Access Compliance Report

Public Rights-of-Way

(Curb Ramps)

Intersection ID: 16483	Main Street: QUEENS_RD	Cross Street: RADCLIFFE_AV	Location: NE
ADA ID: A13A059F2508	Ramp Type: MedianPerp	Initial Pass/Fail: Fail	Overall Compliance: No
Severity Score: 33.75			
Codes/Mitigation Info/Possible Solution		Field Measurements/Component Compliance

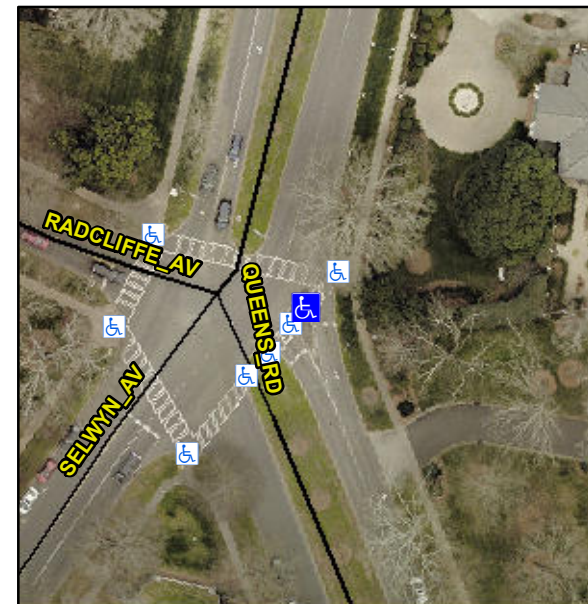
Not Found, R304.5.1, R304.5.3

Compliance	Description	Data	Compliance	Description	Data
N/A	Ramp Length (in)	58.0	Yes	Ramp Slope (%)	6.9
No	Ramp Width (in)	46.0	No	Ramp XSlope (%)	7.2
N/A	Flare Type LT	N/A	N/A	Flare Type RT	N/A
N/A	Flare Slope LT (%)	N/A	N/A	Flare Slope RT (%)	N/A
N/A	Flare Traversable LT?	N/A	N/A	Flare Traversable RT?	N/A
N/A	Landing Length (in)	N/A	N/A	DWS Provided?	N/A
N/A	Landing Width (in)	N/A	N/A	DWS Contrast?	N/A
N/A	Landing Slope (%)	N/A	N/A	DWS Length (in)	N/A
N/A	Landing X Slope (%)	N/A	N/A	DWS Full Width?	N/A
N/A	Landing Curb? (Y/N)	N/A	N/A	DWS Offset (in)	N/A
N/A	Shared Landing?	N/A			
N/A	Gutter Ponding?	N/A	N/A	Gutter Slope (%)	N/A
N/A	Gutter Lip Ht (in)	N/A	N/A	Gutter X Slope (%)	N/A
N/A	Painted X Walk1?	Yes	N/A	Painted X Walk2?	N/A
	X Walk 1 Direction	To NE		X Walk 2 Direction	N/A
N/A	X Walk 1 Width (in)	72.0	N/A	X Walk 2 Width (in)	N/A
	X Walk 1 Slope (%)	5.6		X Walk 2 Slope (%)	N/A
	X Walk 1 X Slope (%)	3.1		X Walk 2 X Slope (%)	N/A

Remove & Replace Entire Ramp.
